UNITED STATES
NUCLEAR REGULATORY COMMISSION
WASHINGTON, D. C. 20555

SUBJECT: MARCH 1984 SITE VISIT - GEOTECHNICAL ENGINEERING REVIEW

Plant Name: Vogtle Electric Generating Plant, Units 1 and 2
Licensing State: OL
Docket Numbers: 50-424/425
Responsible Branch: LB-4; M. Miller, LPM

Subject : Review Comments on Vogtle Submittal of May 8, 1984

DATE 1-6-83	SAMPLE NO. 8541
----------------	--------------------

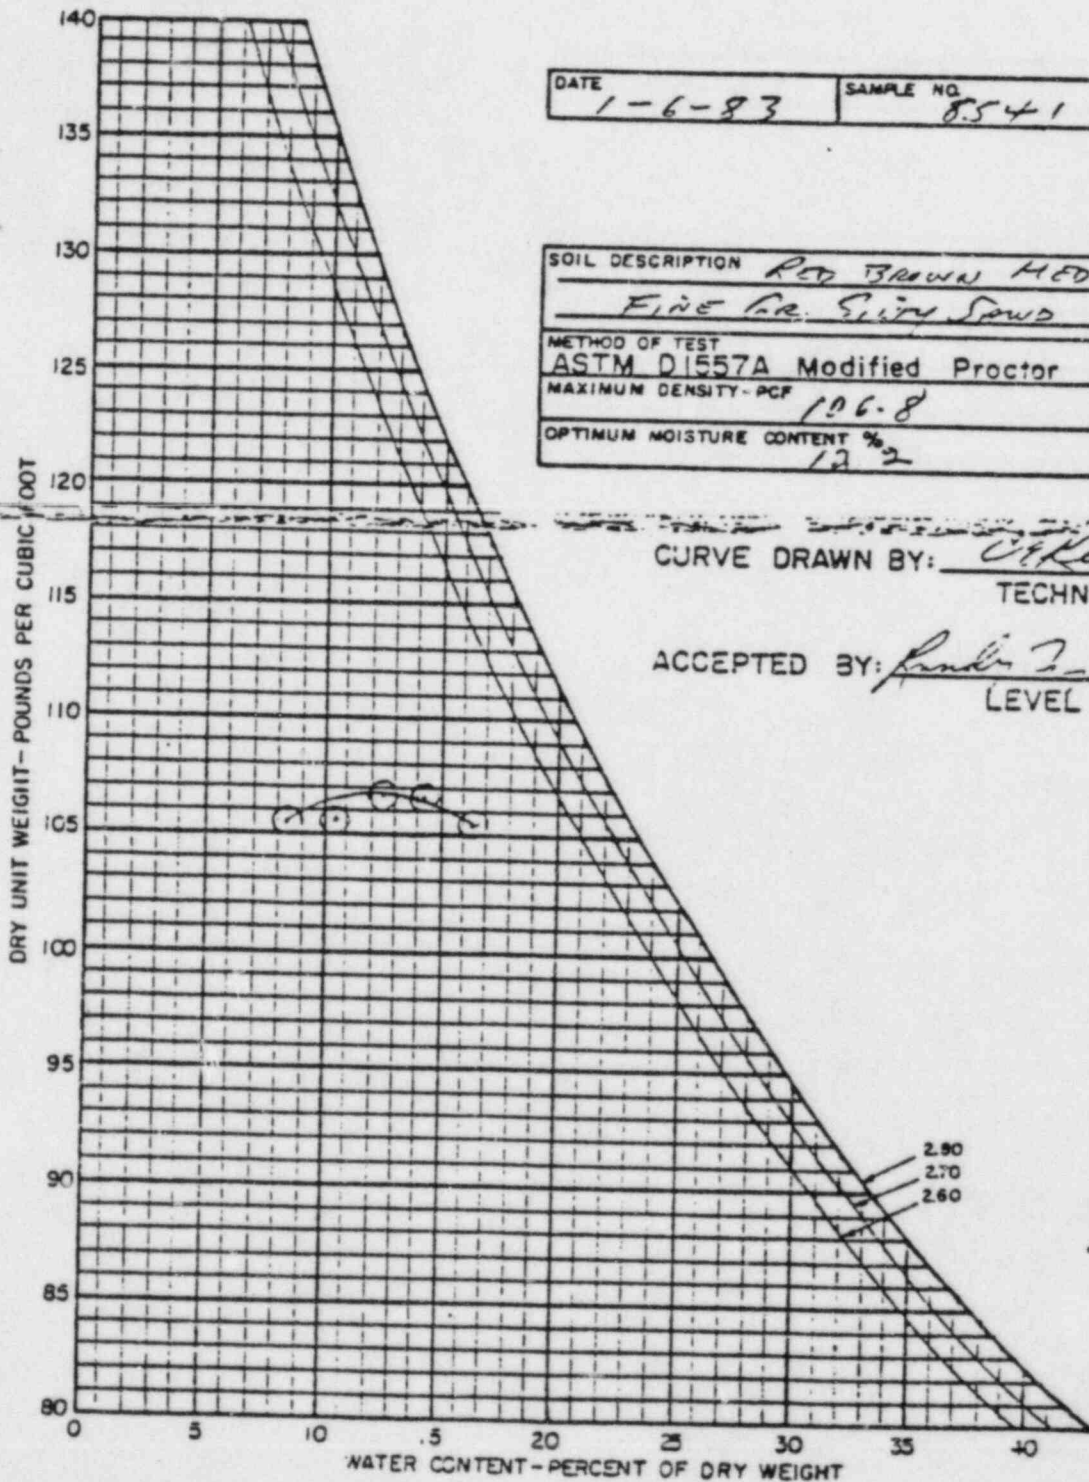
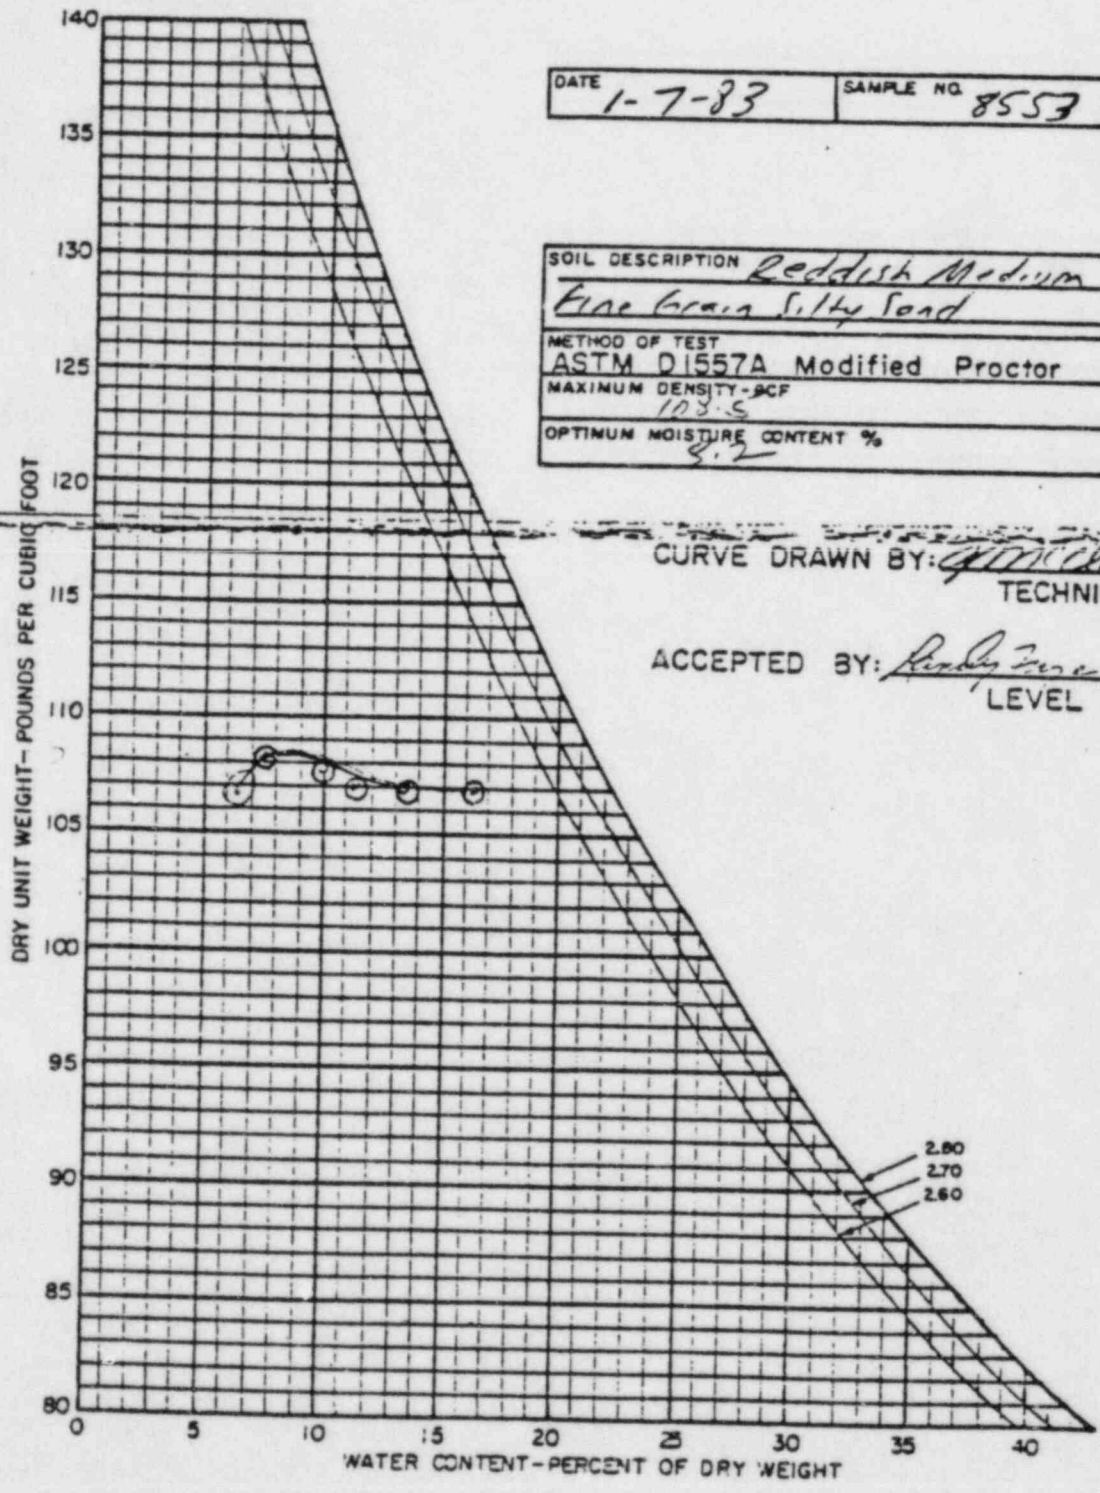
I: Many of the lab compaction tests (ASTM 1557 Modified) appear to be establishing max. dry densities in the range of 103 pcf to 107 pcf which intuitively appear to be 5 pcf to 10 pcf too low. The effect of this occurrence is that the reported percentages of compaction are over 100% which is unlikely and not correct.

Possible reasons for not attaining max. dry density:

- a. Incomplete mixing of water and soil for uniform moisture condition
- b. Insufficient number of water contents (particularly @ max. density) to define compaction curve accurately (See attached compaction curves)
- c. Testing errors (e.g. incorrect volume of mold, non-uniform distribution of rammer blows, etc.)
- d. More appropriate to test for max. dry density in relative density test rather than Modified Proctor.

GPC should be required to verify their lab compaction testing procedures. Preferable to have independent testing (at present Q/A program) in order to compare with already completed results. Independent firm could also be asked to provide recommendations on how to proceed with remaining work (both max. dry density and moisture control). The qualifications of testing firm should be approved by NRR and this firm should be required to provide its proposed testing program for verification

Subject: Summary of Vogt's Compaction Control Test Results for Period
of Jan - June 1983 (For soils with gradation test results only)

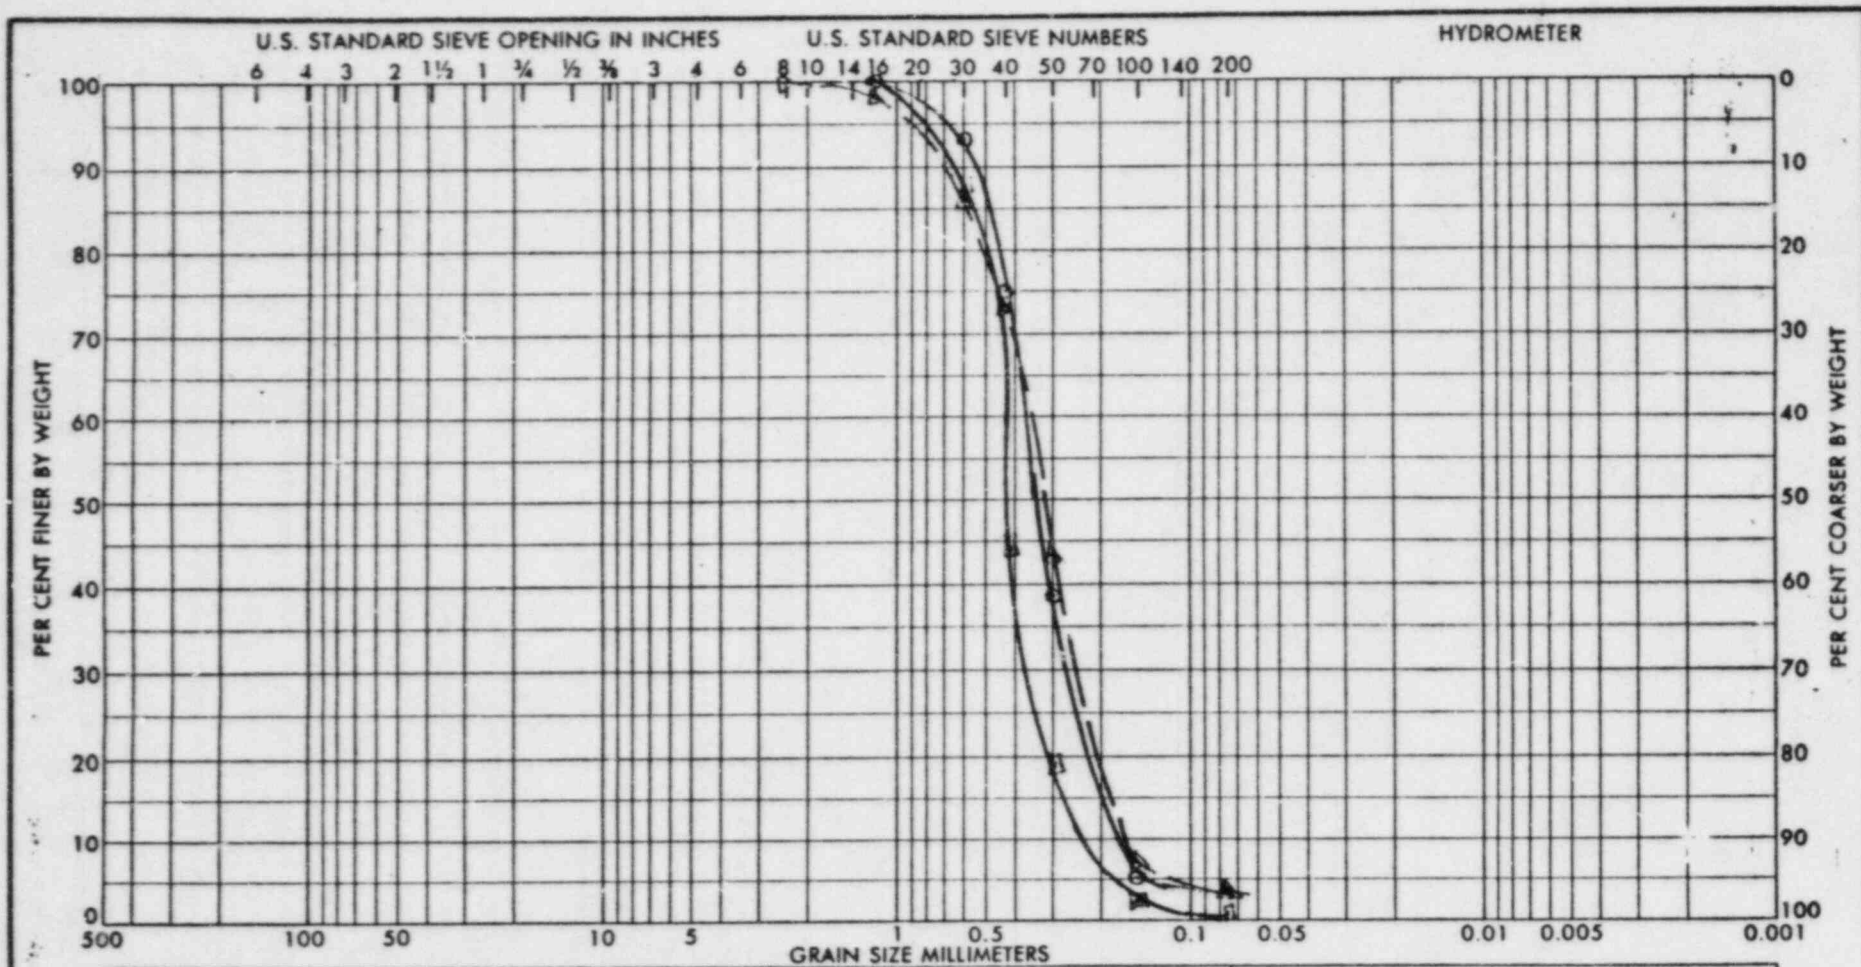
Comments: The gradations for the three types of fill are very similar and it is highly unlikely that they would be distinguishable by eye. The reasons for the wide differences in max. dry densities (e.g. for type 2, range between 101 pcf to 115 pcf) for these seemingly similar materials are not understood. Are the low values of max. dry densities a result of lab testing procedures which require special care and precautions in order to assure that the effects of bulking (or other factors) are eliminated? If there are factors in the lab which make these materials sensitive to dense compaction, then these same sensitive factors would have to be addressed and handled in field compaction (e.g. producing near saturation in order to obtain max. dry densities)

DATE 2-5-83	SAMPLE NO. 8650
----------------	--------------------

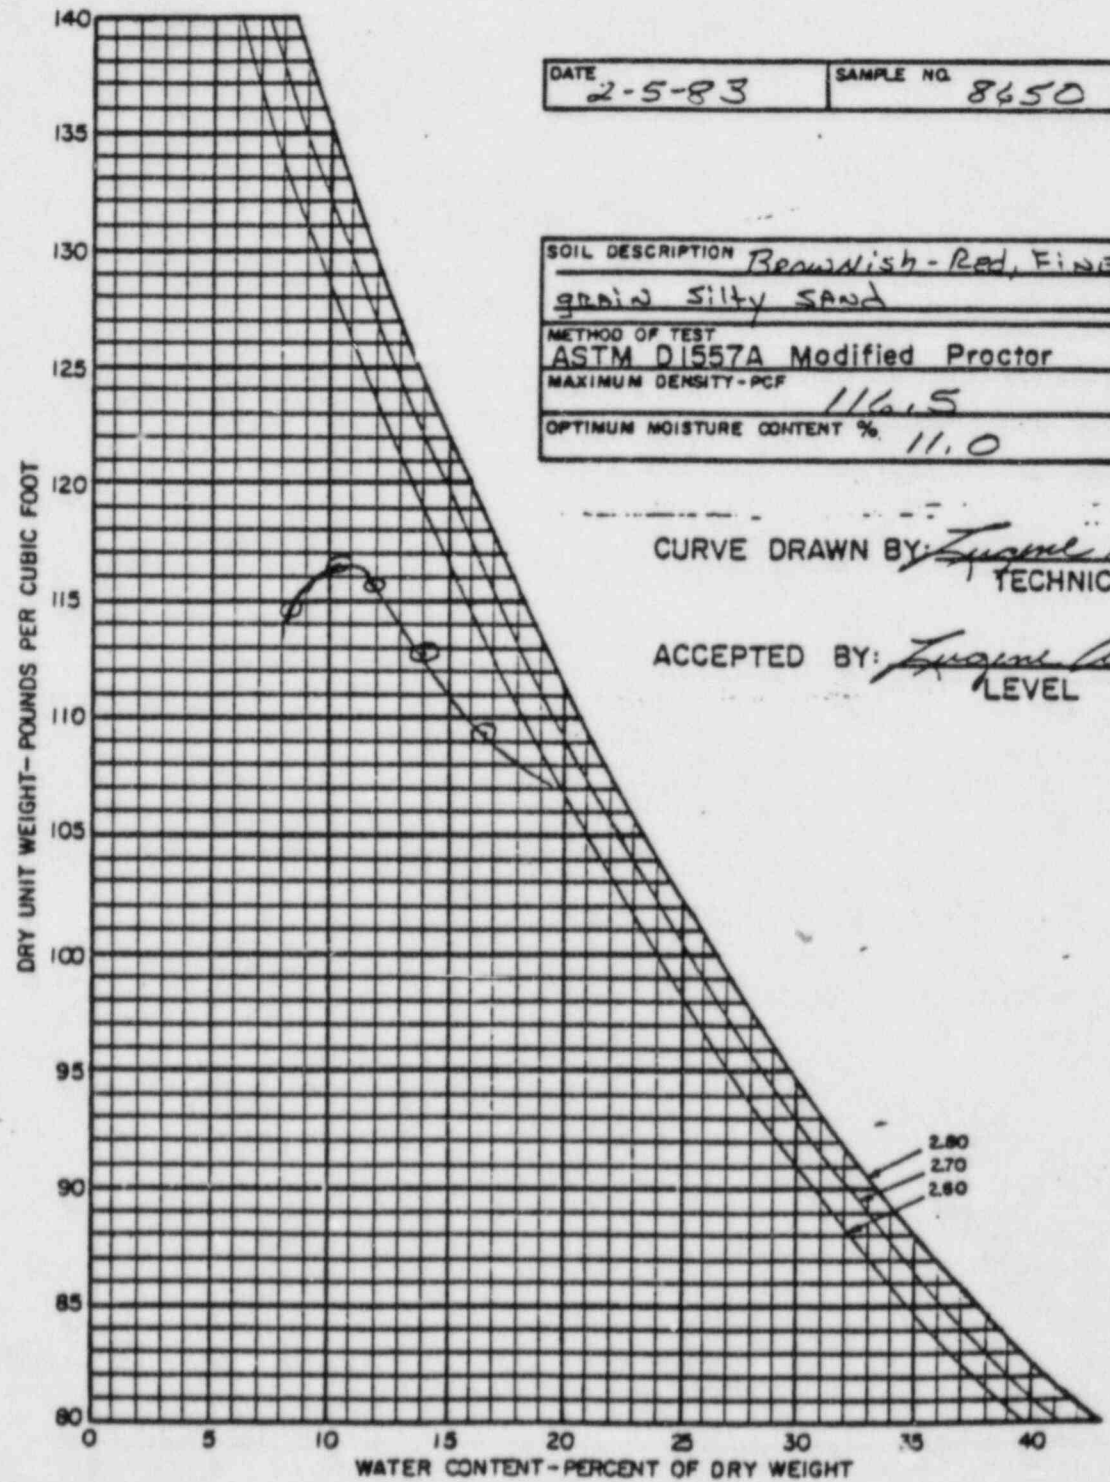
<u>Test No.</u>	<u>% Fines</u>	<u>Lab d_{max} pct</u>	<u>opt mic (%)</u>
1/29	8635	9.2	* 109.2	12.5%
2/5	8650	10.5	* <u>116.5</u>	High p _{stc} 8650 11.0%
2/25	8735	11.0	* 113.4	12.4%
4/26	9040	11.0	<u>105.3</u>	Lowest
4/26	9045	12.3	114.9	9043
4/28	9065	11.6	115.3	
6/7	9385	9.7	* 110.3	14.8
6/26	9515	10.9	113.1	14.8
